Response to comments from NSW government Planning Industry & Environment department:

PROPOSED COMMERCIAL CAR PARKING DEVELOPMENT
BURANDO ROAD, PRESTONS NSW

TITLE:	LANDSCAPE PLAN-1	DWG.No:	LPDA 19 - 195 / 1
SCALE:	1:200 @ A3	DATE:	JUNE 2019
PROJECT:	PROPOSED COMMERCIAL CAR PARKING DEVELOPMENT	DRAWN:	K.Z
LOCATION:	BURANDO ROAD PRESTONS	CHECKED:	R.F

SITE ANALYSIS PLAN

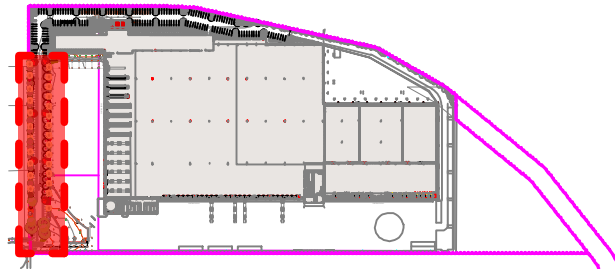
- The proposed Chinese Tallowood species has been removed from the Landscape design and replaced with Claret Ash to achieve an Avenue effect.
- The bulk of the remaining planting has been substituted with **Sandstone Gravel Transition Forest Vegetation & Endemic Cumberland Plain Species**
- The requested salvaging of removed plant material may be achieved by chipping organic material on site and reusing in new garden beds as mulch
- The S4.55 proposes to replace the removal of 51 trees with 62 trees, achieving greater than a 1:1 tree replacement ratio
